1. PCI Engineering Change Notice – MSI-X

TITLE:	MSI-X
DATE:	June 10, 2003
AFFECTED DOCUMENT(S):	PCI Local Bus Specification, Revision 2.3 & 3.0 Draft
SPONSOR:	Joe Cowan; Hewlett-Packard Company

1.1. Summary of the Functional Changes

Figure 6-1: ~~Message Signaled Interrupt~~MSI Capability Structures

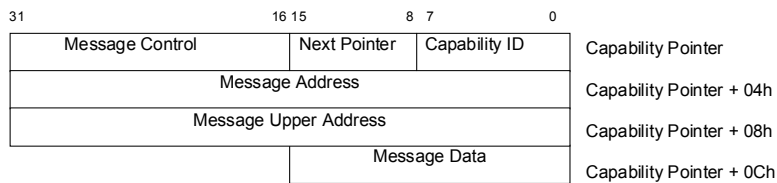
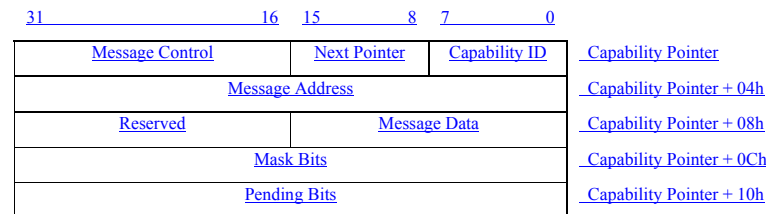
[A function supporting MSI implements one of four MSI Capability Structure layouts illustrated in Figure 6-1, depending upon which optional features are supported. If a function supports 64-bit addressing \(DAC\) when acting as a master, the function is required to implement 64-bit addressing.](#)

~~The capability structure for a 32-bit message address (illustrated in Figure 6-1) is implemented if the function supports a 32-bit message address. The capability structure for a 64-bit message address (illustrated in Figure 6-1) is implemented if the function supports a 64-bit message address. If a device supports MSI and the device supports 64-bit addressing (DAC) when acting as a master, the device is required to implement the 64-bit message address structure.~~
